FIREFOX

Amplifone Raster Modification

4. Deflection Board

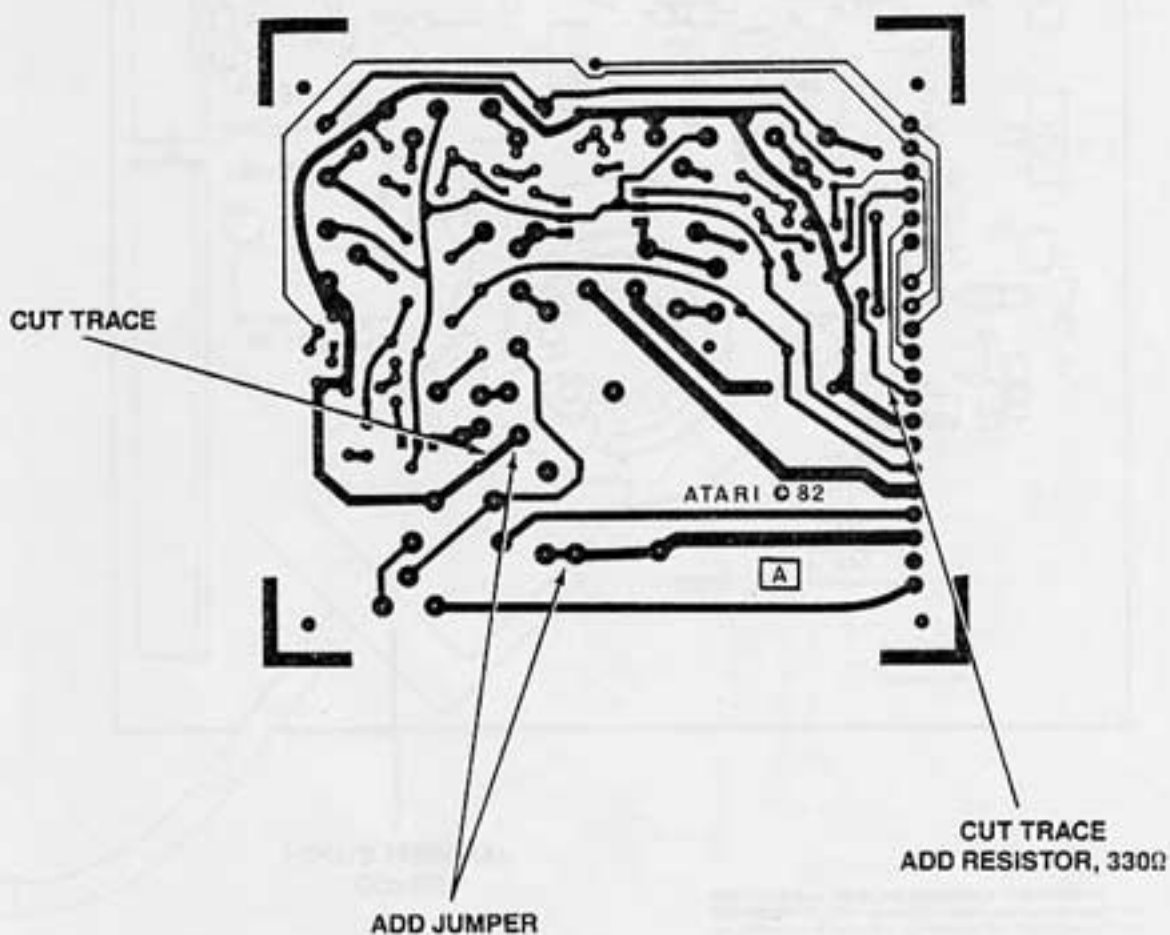
Install a 1N751A zener diode (5.1 V) to the vertical sync input, anode to ground, as follows:

- a. Locate the first pad connected to J1 pin 5 on the trace or circuit side of the board. Note: PLL board is installed in place of J1.
 - b. Locate the pad going to ground near J1 pin 6, between pin 6 and R10.
 - c. Install the zener diode (anode to ground) between these two pads on the circuit side of the PCB.
5. a. Remove C5 (0.1 μ F) axial cap.
b. Install a 0.22 μ F (25 V) axial cap between the cathode and gate of Q4 (MCR101), soldering one lead of the cap to the cathode pad (square pad) of Q4 and the other lead to the pad of C5 connected to the gate of Q4. Install the cap on the circuit side of the PCB.
 6. Route the high-voltage anode lead away from the deflection board, and secure it with a wire tie wrap.

Neck PCB Assembly

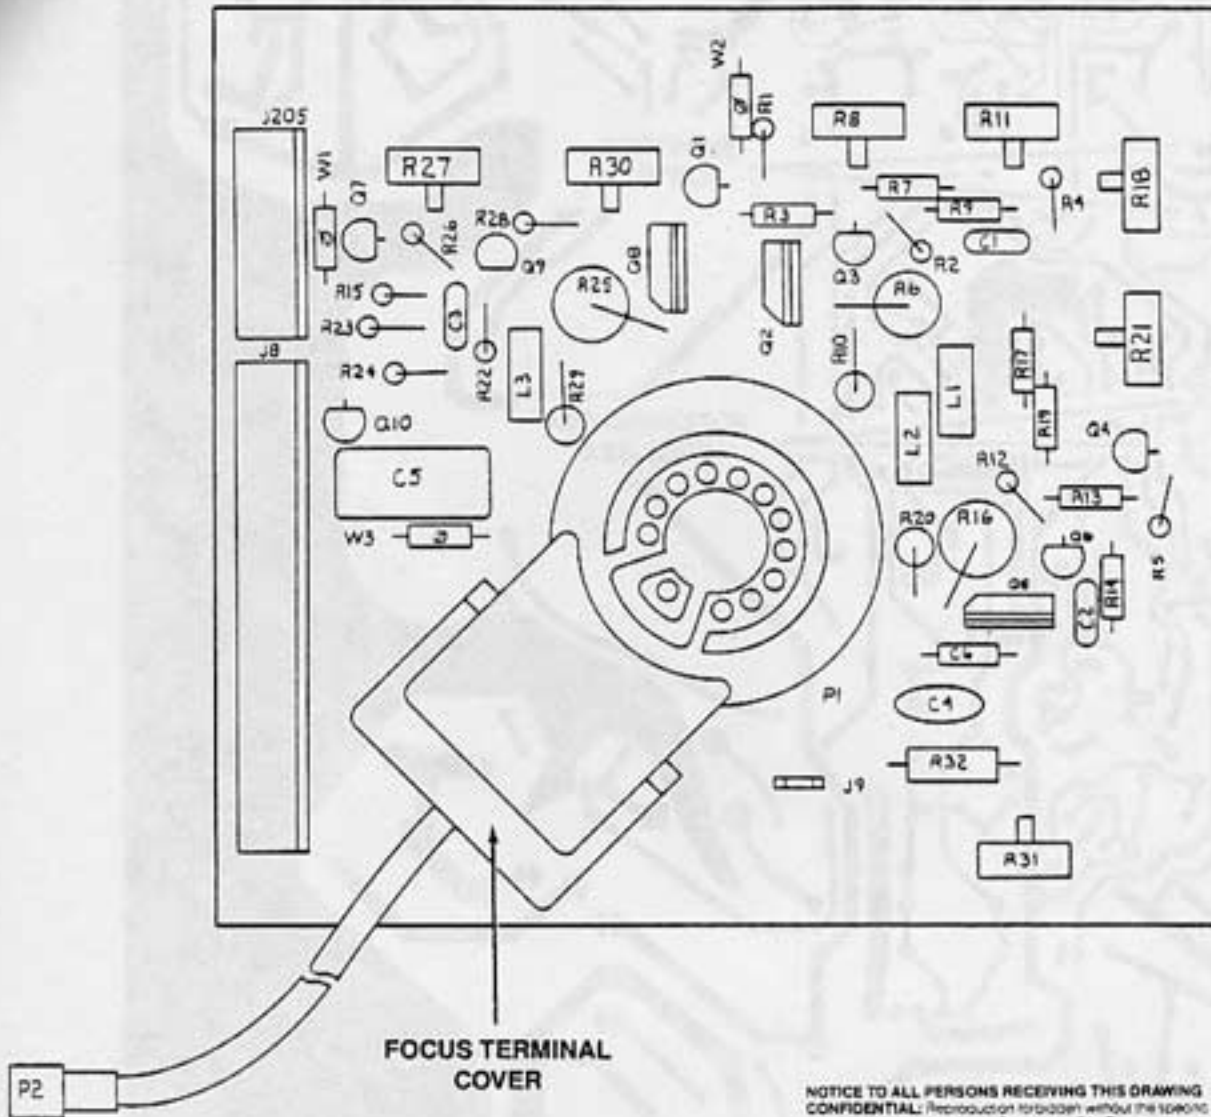
1. Neck Board

Cut the trace between the pad at CRT socket pin 5 and the nearest pad. Install an insulated jumper (1000 volts or better insulation) between pad at CRT socket pin 5 and either of the pads at spade lug J9. Use a number 20 wire.

2. Cut the trace between connector J8 pin 9 pad and the base pad of Q10. Install a 330 ohm, $\pm 5\%$, $\frac{1}{4}$ watt, resistor between the base of Q10 and the connector J8 pin 9 pad.

3. Remove the focus terminal cover from the CRT socket and unsolder the focus lead from the terminal. Solder a 22 meg-ohm, $\pm 5\%$, $\frac{1}{2}$ watt carbon-composition resistor to the terminal with the end flush with the terminal and resistor parallel to the board. Solder the focus lead flush with the other end of the resistor, and trim the resistor lead. Route the focus lead back to the exit groove, and replace the cover.
